Re: FortisBC Energy Inc. (FEI)
Project No. 1599152

Application for a Certificate of Public Convenience and Necessity for the Okanagan Capacity Upgrade Project (Application)

Response to the Residential Consumer Intervener Association (RCIA) Information Request (IR) No. 3

ITS Forecasted Peak Demand Comparison

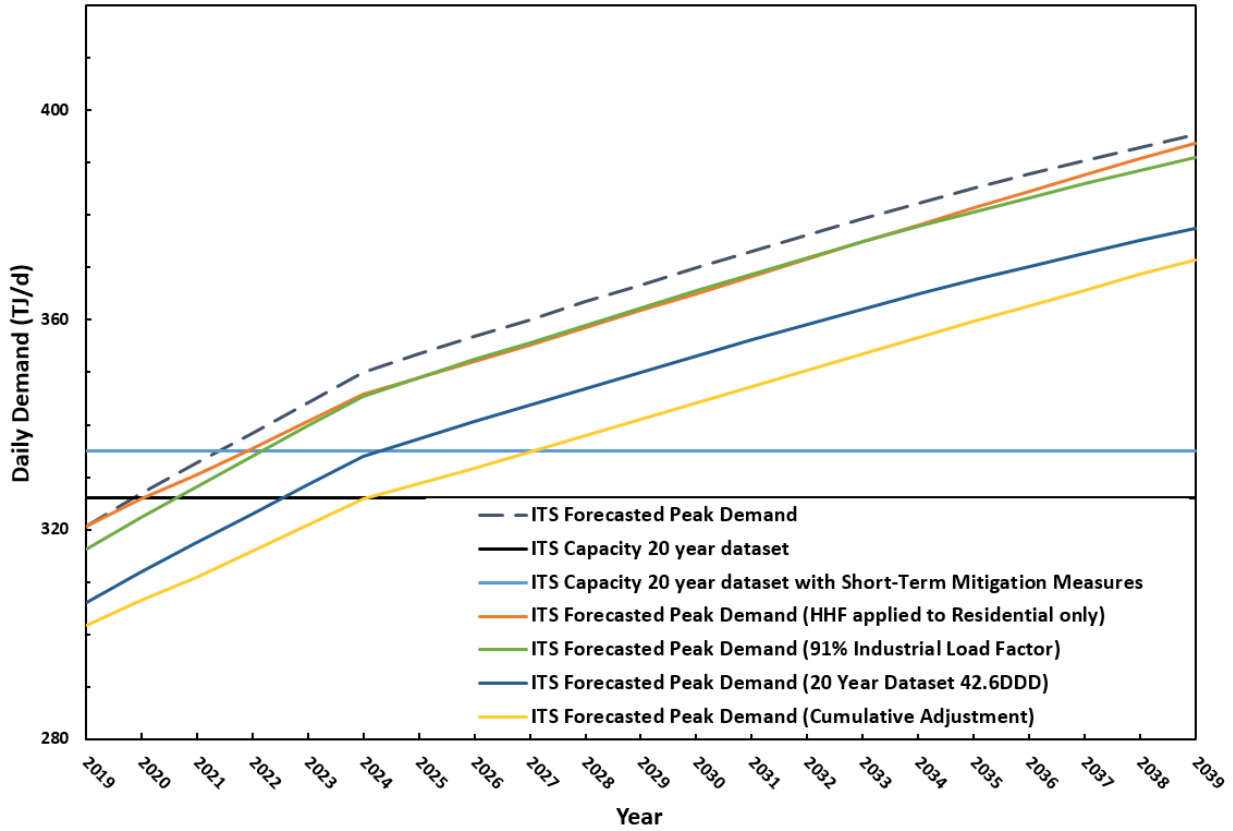
10
11 44.1 RCIA IR2 31.1 requested the three adjustments separately but neglected to also
12 ask for the cumulative impact of the three to be shown. Please reproduce the
13 graph in FEI’s response to RCIA 31.1 showing the three adjustments separately
14 as well as the cumulative adjustment. When reproducing the graph, please use
15 the same scale as the original Figure 4-1. Please include the ITS capacity with
16 short-term mitigation, as shown in Figure 4 1.

19 The requested revised figure is provided below. With the cumulative adjustment, and all short-
20 term mitigation measures in place, the speculative forecast suggests that the apparent need for
21 the OCU Project would move to 2027. The most significant influence on the timing of the
22 apparent need derives from a warmer design temperature resulting from a smaller historical
23 dataset. As discussed in the response to BCUC IR2 43.3.2, FEI’s position is that a 60 year
24 dataset for determining the design temperature is appropriate. Designing upgrades using
25 shorter return periods increases the probability of experiencing weather colder than the system
26 can support and unacceptably increases the risks of supply shortfalls to FEI’s customers during
27 extreme cold winter conditions.
